Chlor-alkali plant expansion to 42,000 tpa, Kwinana

Nufarm-Coogee Pty Ltd

**Report and recommendations of the
Environmental Protection Authority**

**Environmental Protection Authority
Perth, Western Australia
Bulletin 845
March 1997**

Figure 3. Individual risk contours for Nufarm-Coogee Kwinana Chlor-Alkali Plant expansion (50 tonne storage tanks). (Source: VRJ Risk Engineers Pty Ltd, 1996)

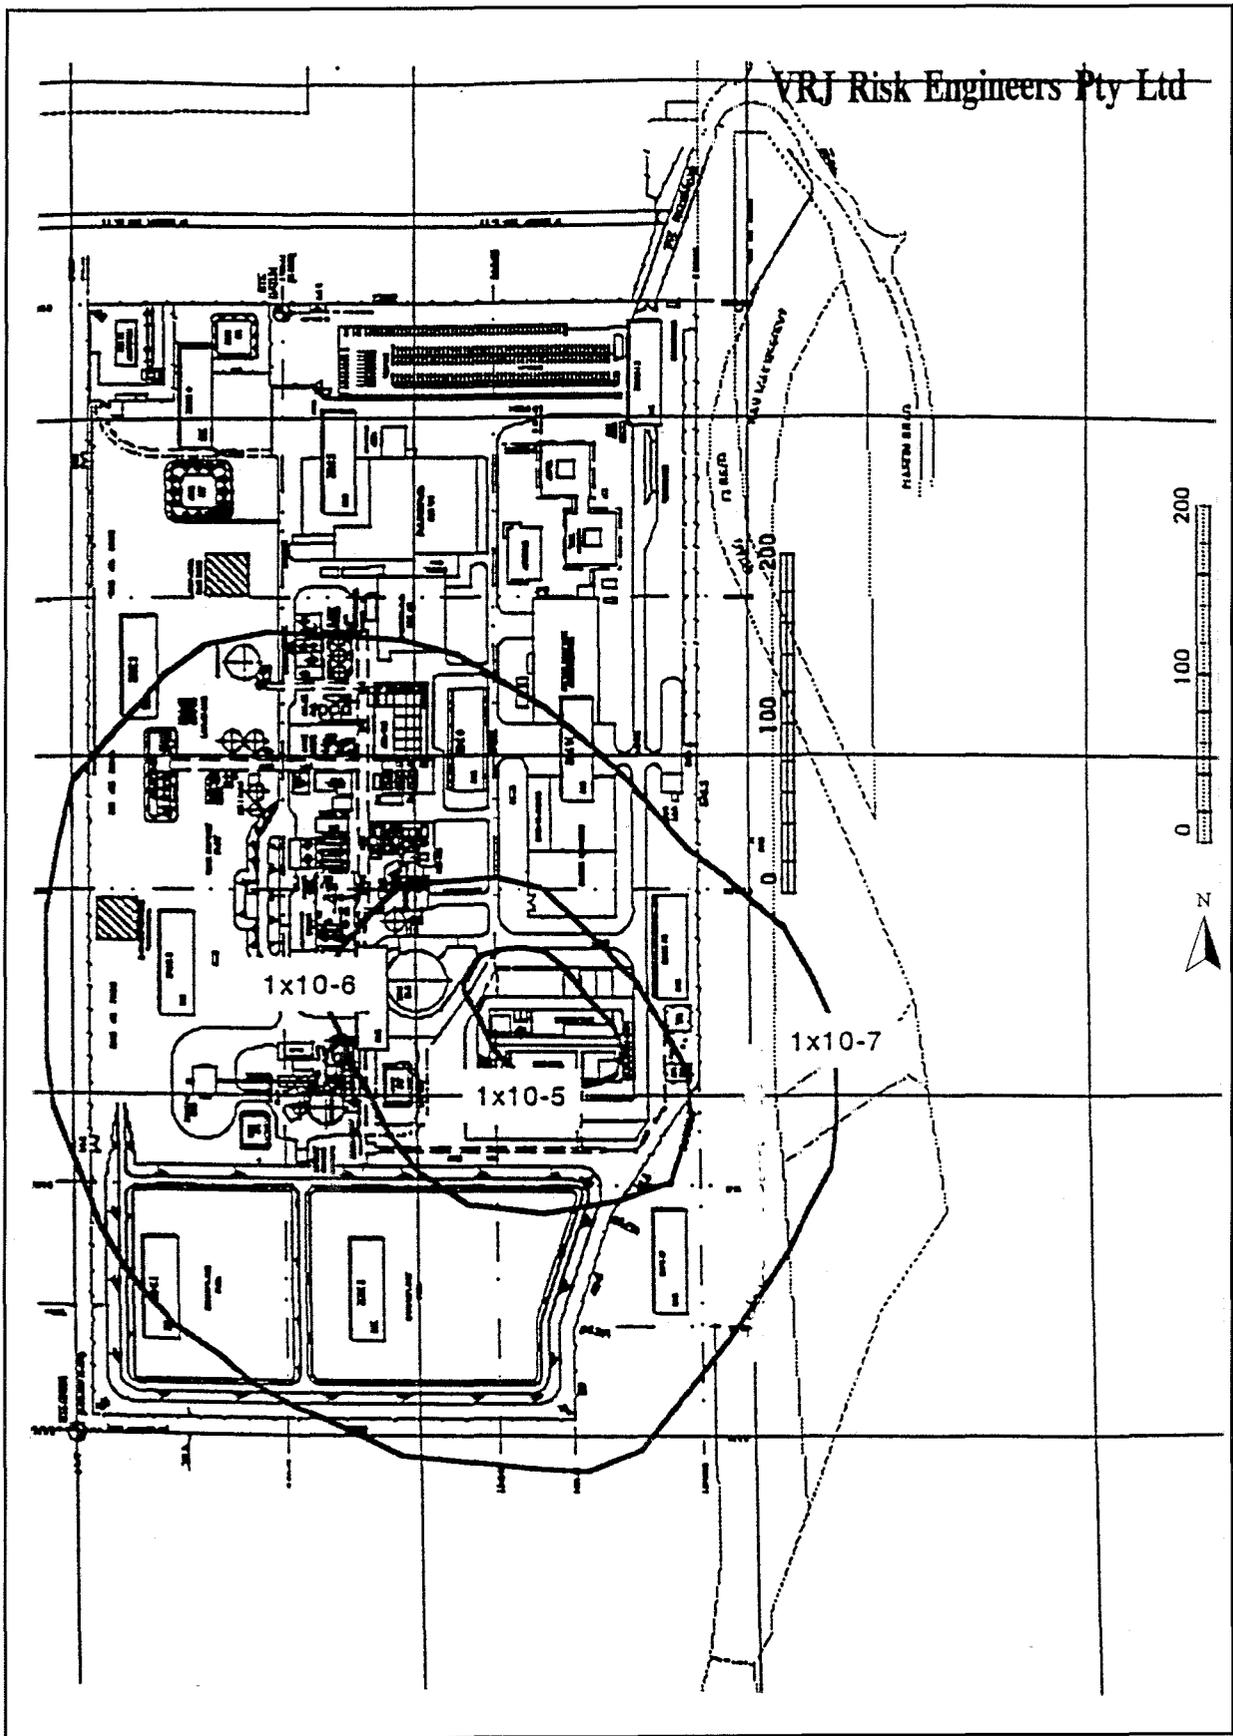
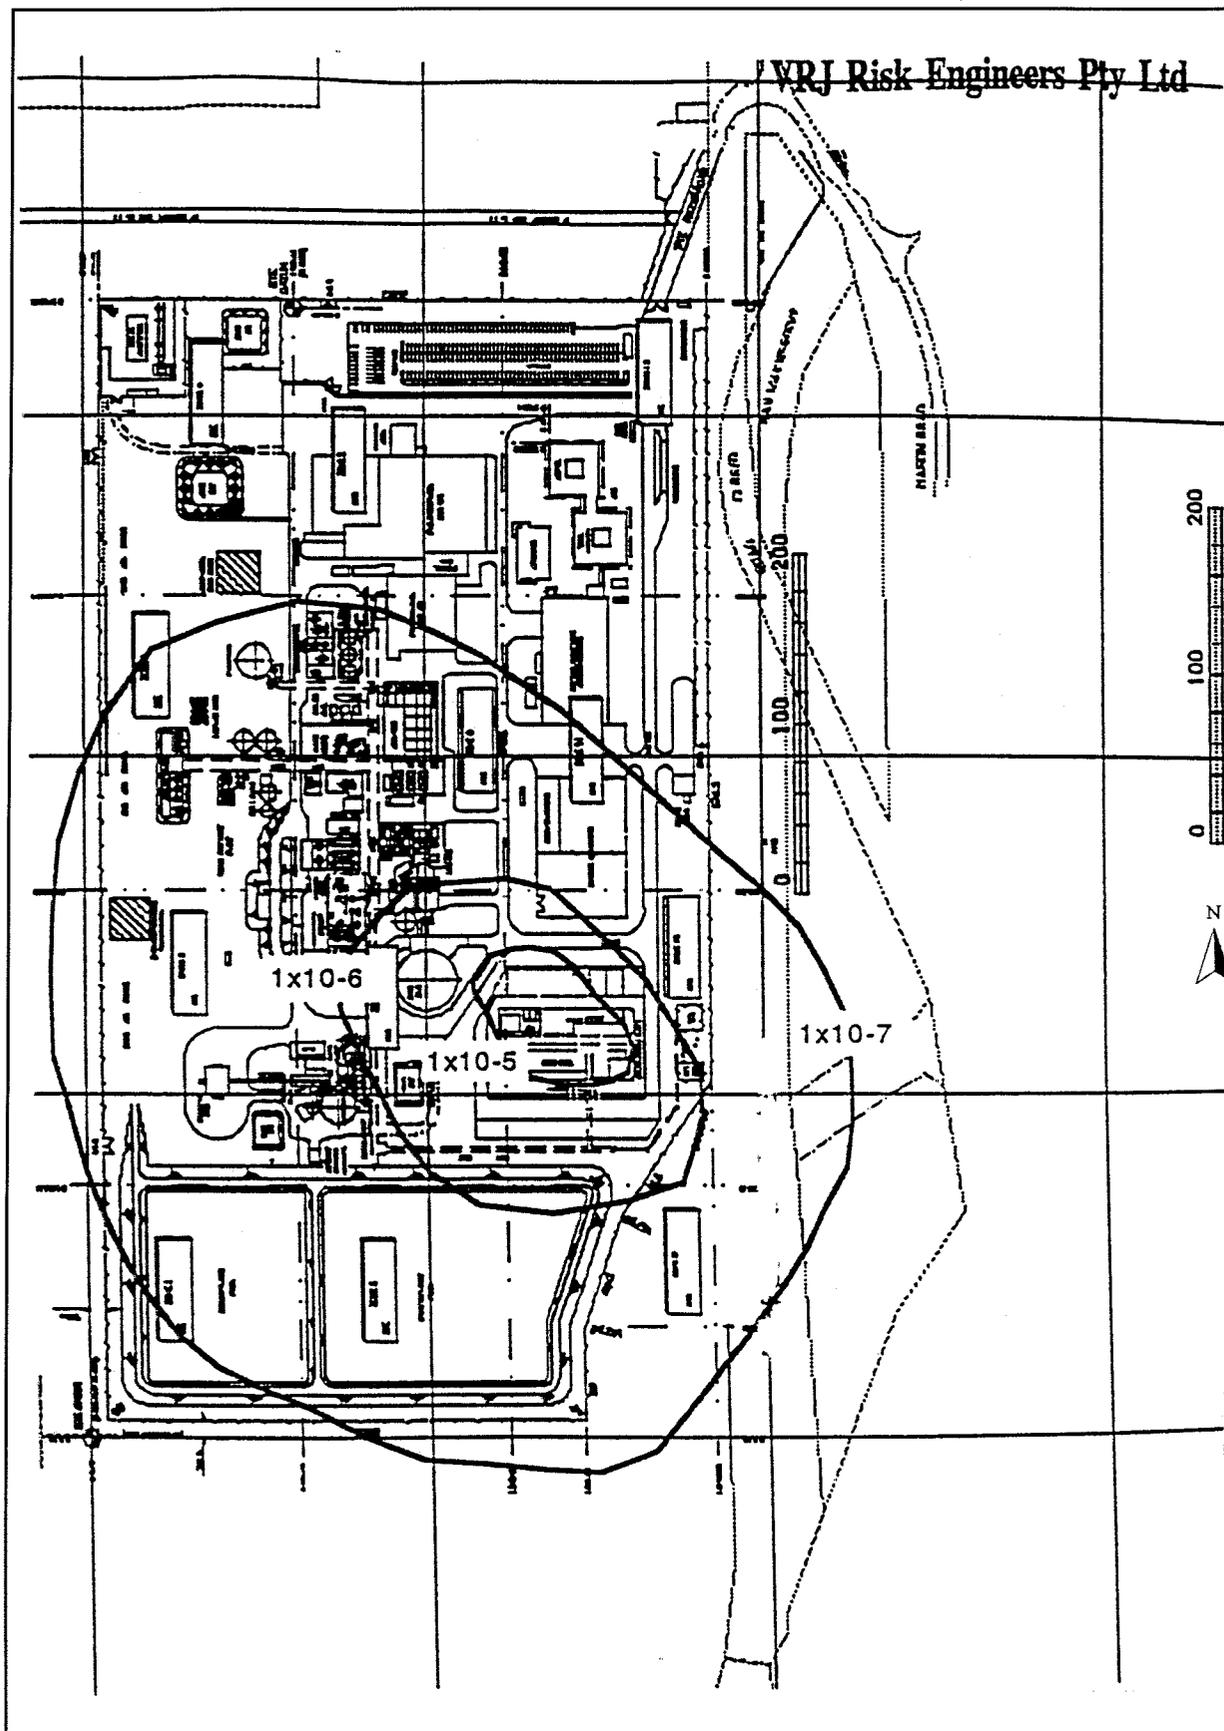
Preliminary quantitative risk assessment (QRA) of the proposed expansion, including both existing and proposed production plant, has been carried out by VRJ Risk Engineers Pty Ltd (Nufarm-Coogee 1996c). Again, chlorine was considered to be the only material which contributed to individual risk calculations. Risk contours for the expanded operation, including existing and proposed plant, are shown in Appendix 1: Figure 2 for three additional 25 tonne storage tanks and in Appendix 1: Figure 3 for three additional 50 tonne storage tanks.

The EPA notes that the QRA has shown that individual risk can be held to an acceptable level when the capacity of the three new chlorine storage tanks is 50 tonnes each and the maximum on site storage of chlorine is 150 tonnes (Appendix 1: Figure 3). This result is due to the adoption of best practice storage designs and the additional safeguard of installing liquefaction and vaporisation equipment within a secondary containment building. This result agrees with a study undertaken by J A Goldsmith, (Quantarisk 1991), for the EPA, which concluded that the design of the chlorine storage facility could be a more important factor in determining overall risk than the size of the storage vessel.

The EPA notes that previously bulk chlorine storage has been limited to a 50 tonnes maximum. This conservative limit was placed on storage due to limited knowledge about chlorine storage and clear public concern, and the fact that risk assessment was still in its formative stage. As a consequence of improved engineering and safety design for chlorine storage in Western Australia, the development of risk assessment capability and the satisfactory safety performance of chlorine producers in Western Australia, the EPA considers that should a proponent wish to increase on-site chlorine inventory, the proposal should be referred to the EPA for assessment. Any such proposal should undergo a quantified risk assessment to demonstrate compliance with EPA individual risk criteria and societal risk criteria, when the latter have been set. It has been shown that the EPA's objective with regards to individual risk can be met by this proposal.

Figure 4. : Societal Risk Results

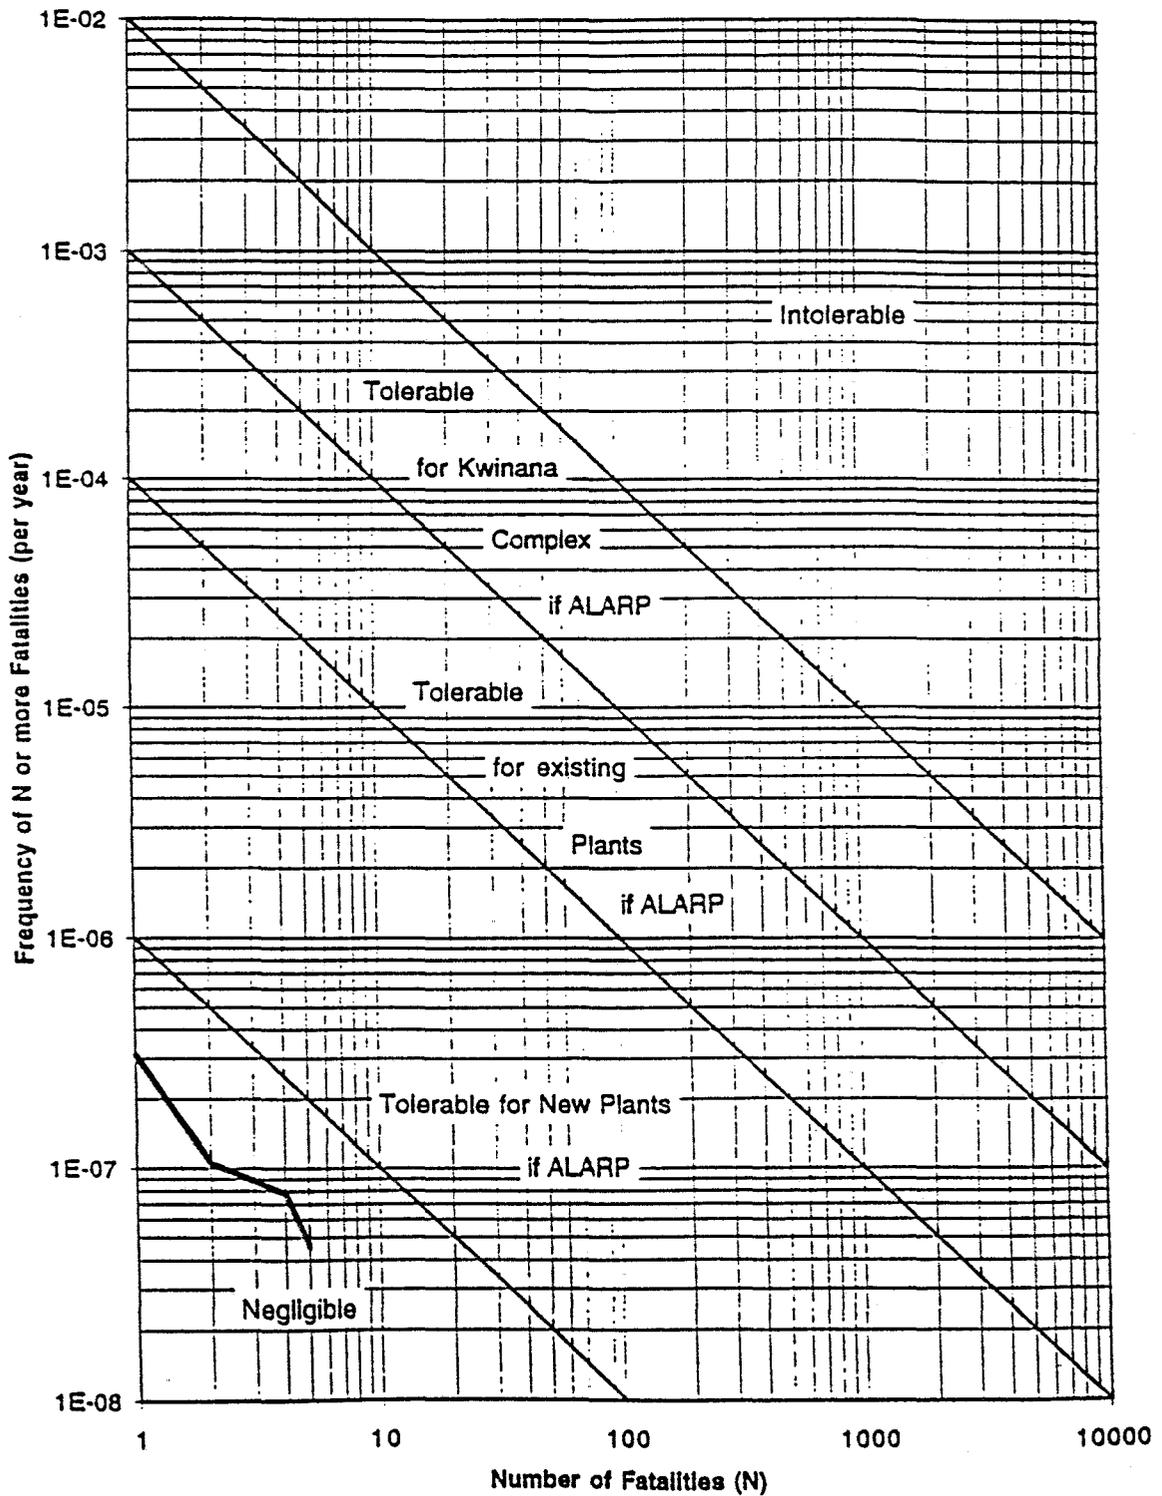
The EPA notes that using the guidelines from the Technica 1990 study, VRJ Risk Engineers Pty Ltd (Nufarm 1996c) have found that the societal risk for the expanded plant falls within the "negligible " area of the graph (Appendix 1: Figure 4).
